SERVICE BULLETIN

M-854

SAFETY RECALL CODE 056

REAR BRAKE — 1982 FXR AND XL MODELS

Figure 1. Rear Brake Plunger

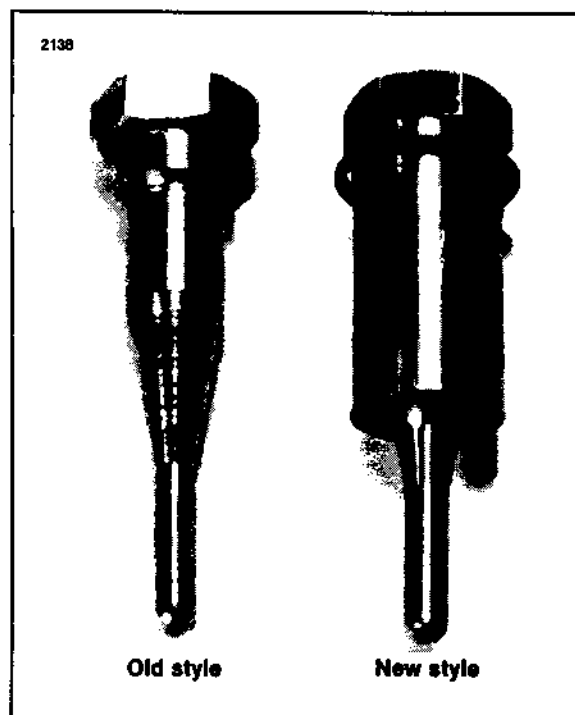
Your total requirements of 056 Rear Brake Plunger Kit, Part No. 93420 will be shipped to you no charge, freight prepaid. Each Kit contains one replacement brake plunger and lock ring. See Figure 1.

Figure 2. Rear Brake Control — XL Models

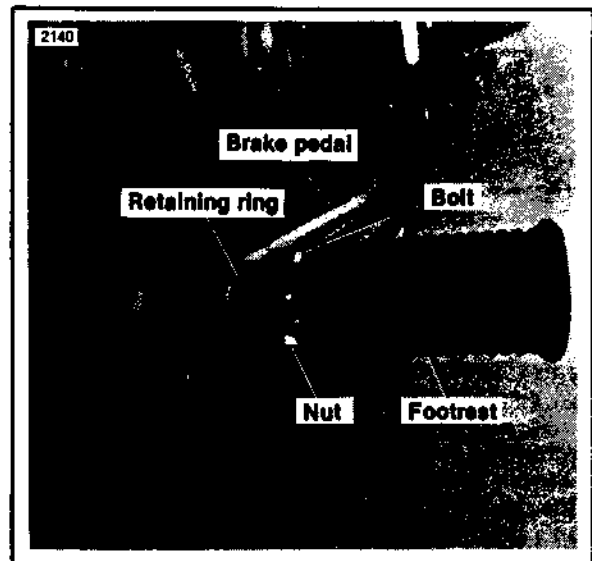
1. See Figure 2. Remove the bolt, nut and footrest. Remove the retaining ring from the pivot shaft.
2. See Figure 3. Remove the rear brake master cylinder mounting hardware. Remove the brake pedal/plunger assembly, boot (4), cupped washers (5, 5a) and spring (6). Discard cupped washer (5a).
3. Loosen locknut and unscrew the old style plunger from the rod end and replace it with the new style plunger from kit, Part No. 93420. Make sure lock ring from kit is installed on the plunger. Secure the locknut (2) against the plunger.

4. Assemble the boot (4), spring (6) and cupped washer (5) onto the new plunger. Install the brake pedal assembly onto the motorcycle and position the plunger into the master cylinder so that it registers in the piston. Install the master cylinder mounting hardware. Tighten bolts to 155-190 in-lbs torque. Make sure drain hole in boot is positioned towards the bottom.
5. See Figure 2. Install the retaining ring, footrest, bolt and nut.

Figure 3. Rear Brake Control — Exploded View

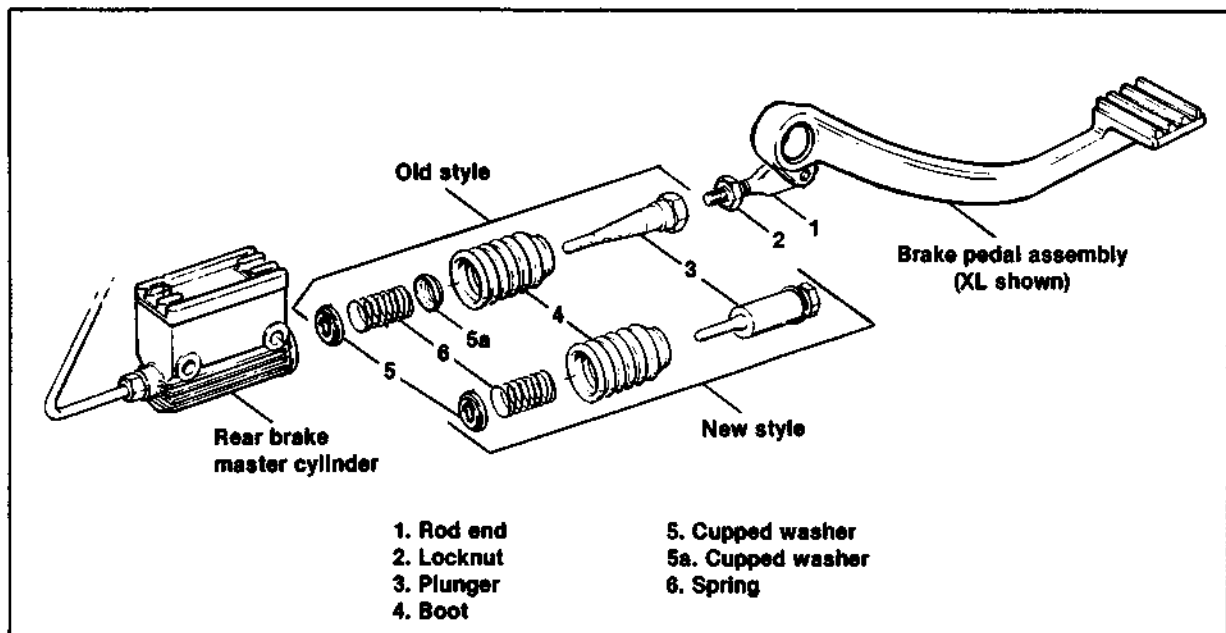
1. See Figure 4. Remove the rear brake master cylinder mounting hardware.
2. See Figure 3. Remove the boot (4), cupped washers (5, 5a) and spring (6). Discard washer (5a).
3. Loosen locknut and unscrew the old style plunger (3) from the rod end and replace it with new style plunger, Part No. 93420. Make sure lock ring from kit is installed on plunger. Secure the locknut against the plunger.
4. See Figure 3. Reinstall the boot(4), spring (6) and cupped washer (5) on the new plunger. Make sure drain hole in boot is positioned towards the bottom.
5. Position the plunger into the master cylinder so that it registers in the piston. Install the master cylinder mounting hardware. Tighten bolts to 155-190 in-lbs torque.
